MARK	DESCRIPTION	DATE	APPR.
1	REV IN ACCORDANCE WITH AMDT 0004	DEC 2017

HURRICANE & STORM DAMAGE REDUCTION
RARITAN BAY & SANDY HOOK BAY
PHASE II, CONTRACT 4
FORT MONMOUTH, NJ

TYPICAL FLOOD TRANSITION DETAIL

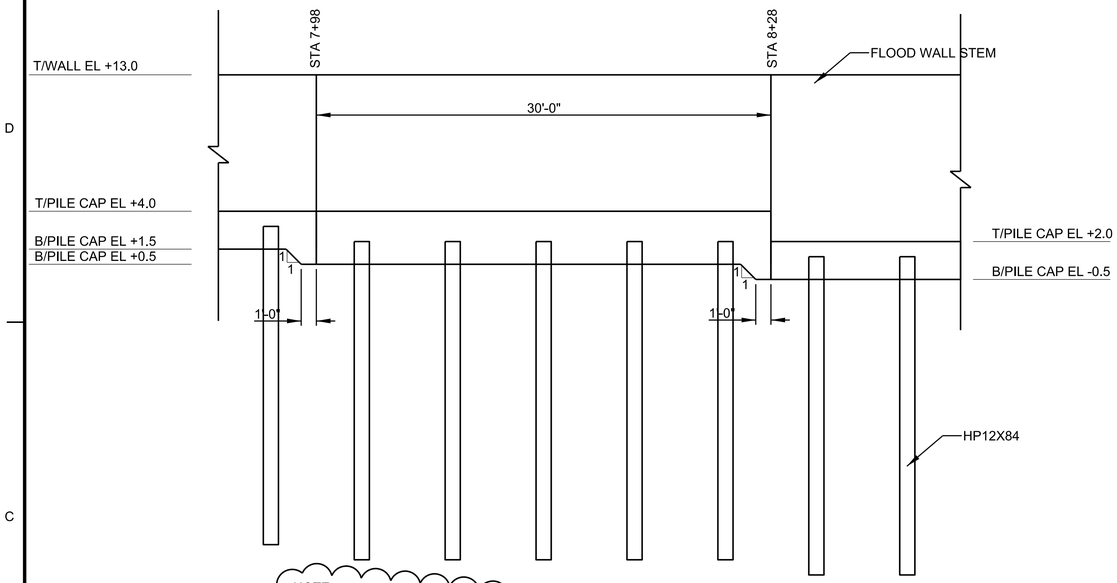
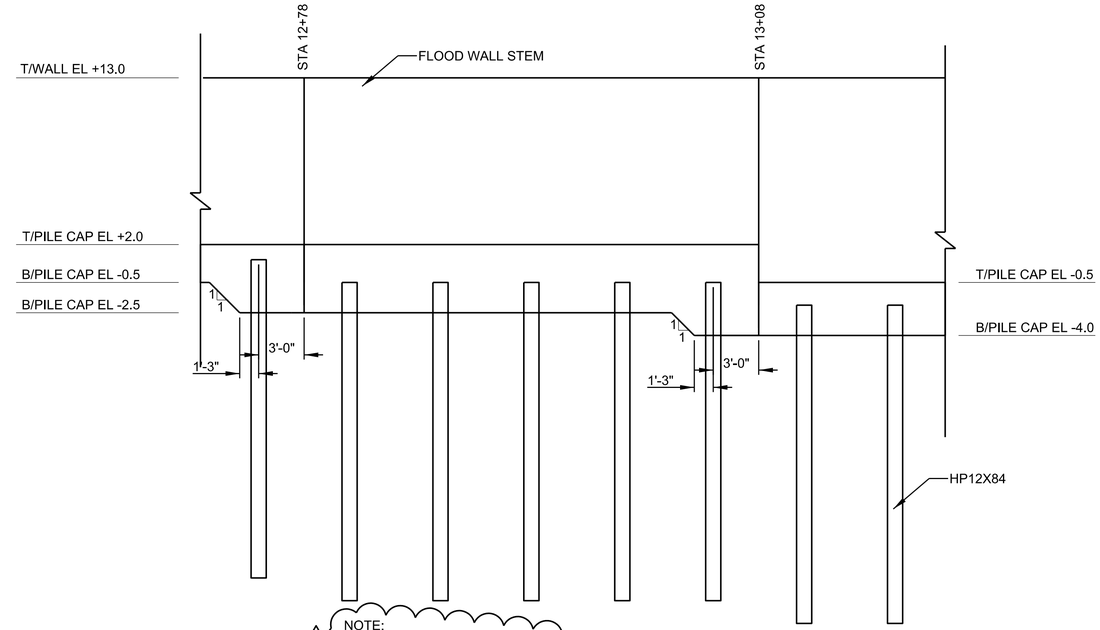
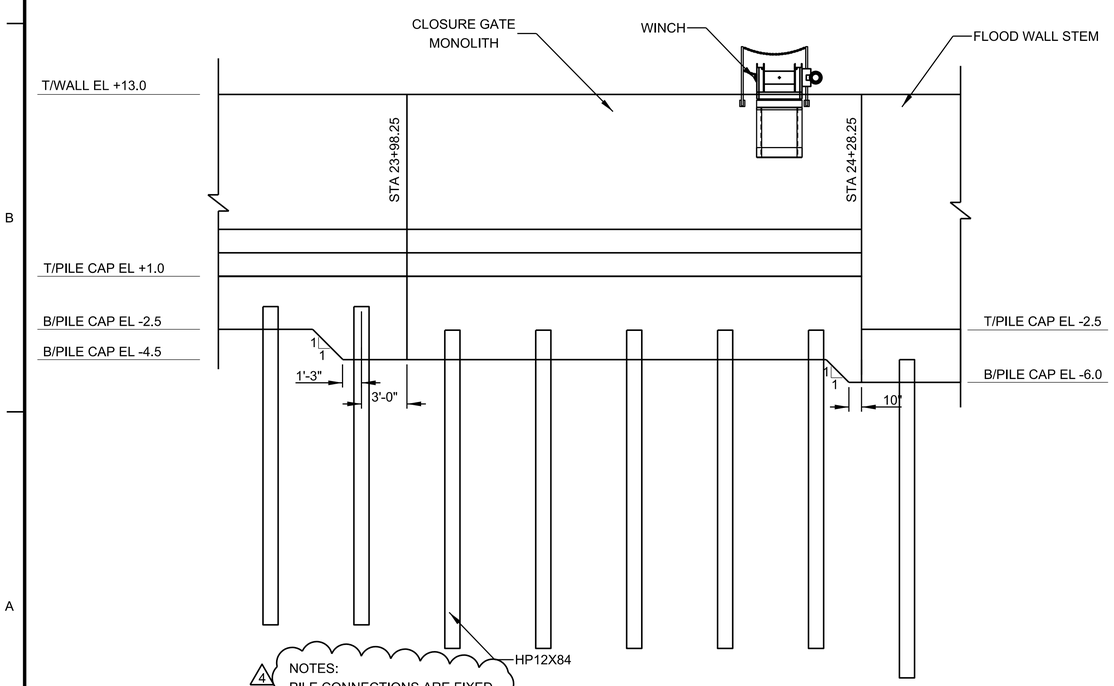
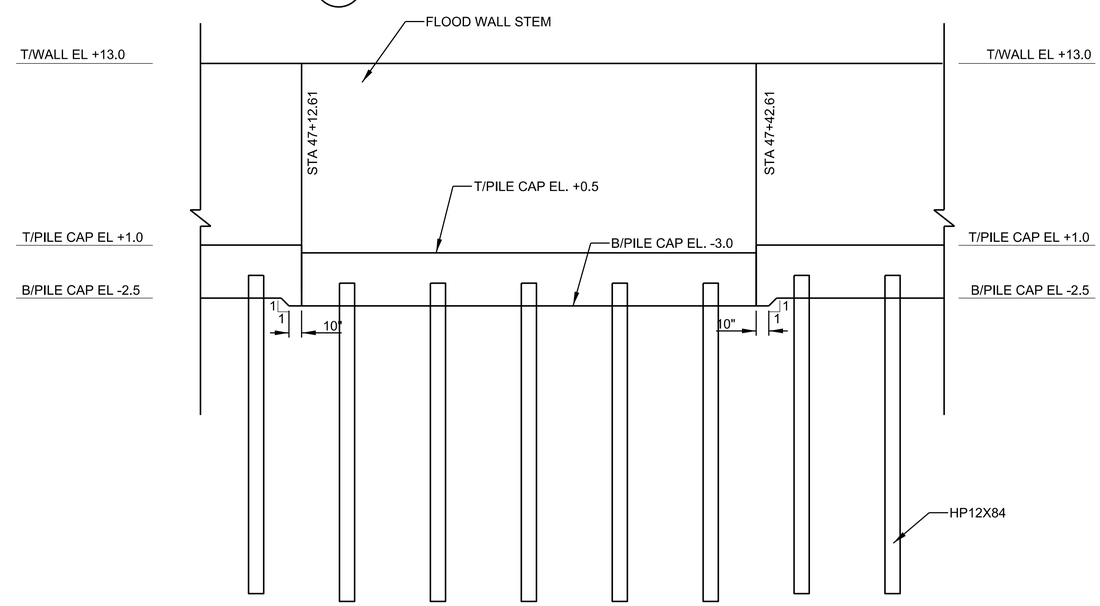
MARK	DESCRIPTION	DATE	APPR.	MARK	DESCRIPTION	DATE	APPR.
4	NOTE ADDED	DEC 2017

4 NOTE:
PILE CONNECTIONS ARE PINNED.

4 NOTE:
PILE CONNECTIONS ARE PINNED.

4 NOTES:
PILE CONNECTIONS ARE FIXED.

4 NOTES:
PILE CONNECTIONS ARE FIXED.
